## Development Permit Panel

Wednesday, January 16, 2019  
3:30 p.m.

1. **DEVELOPMENT PERMIT 16-754761**  
(REDMS No. 6013813 v. 2)

PROPERTY LOCATION: 6560, 6600, 6640 and 6700 No. 3 Road

**A201**

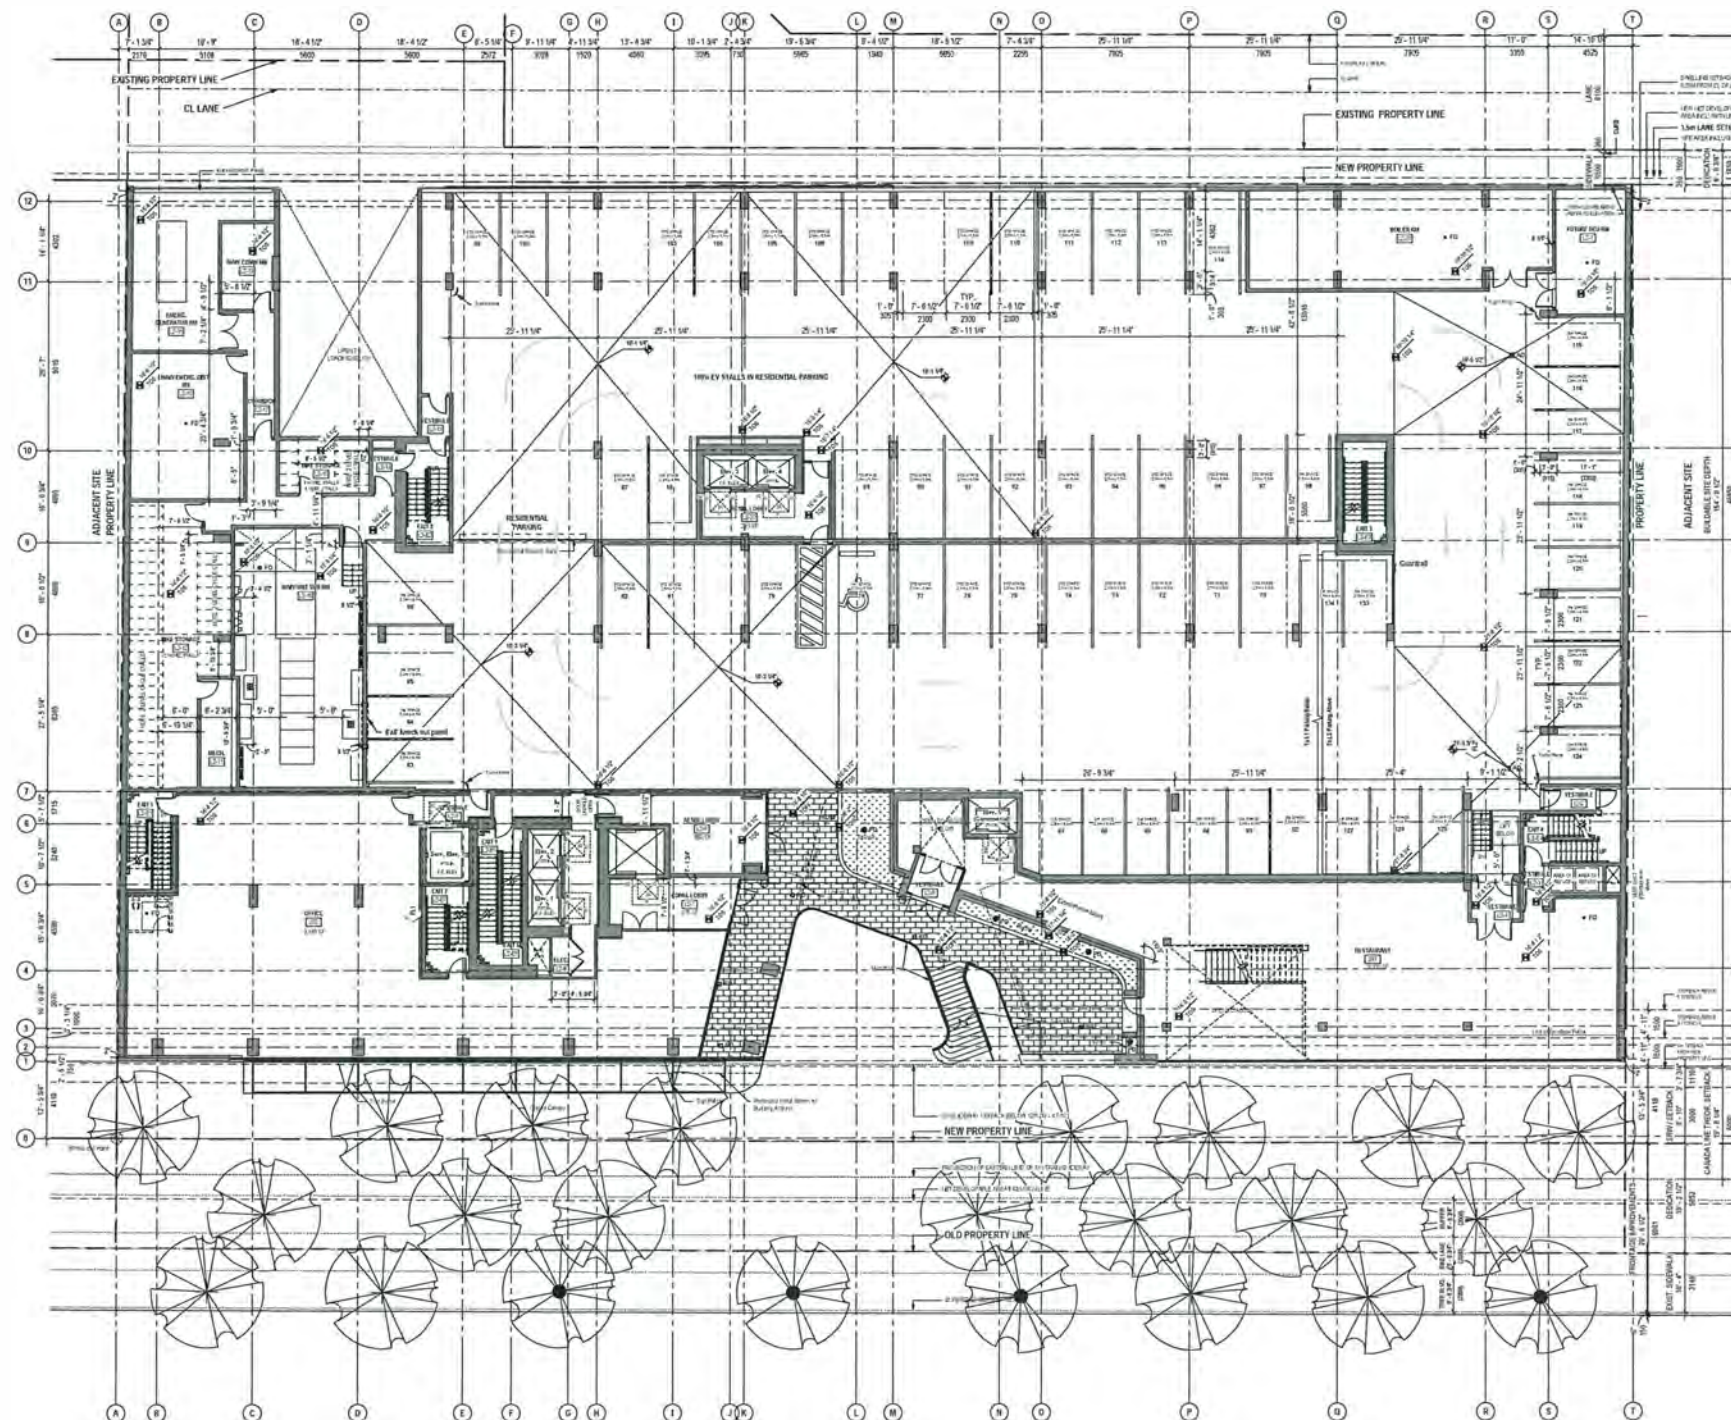
- the applicant should have included rooms for the District Energy System (DES) and mechanical units in the plans submitted to Panel; the applicant is also advised of the requirement for vestibules in the entrances of big CRUs;

***DIALOG (Arch): The DEU Room is in the plans package and located in the SE corner of the project on Level 02 (Sheet A201). CRU Units over 3000 sq. ft. will have a vestibule at the entry.***
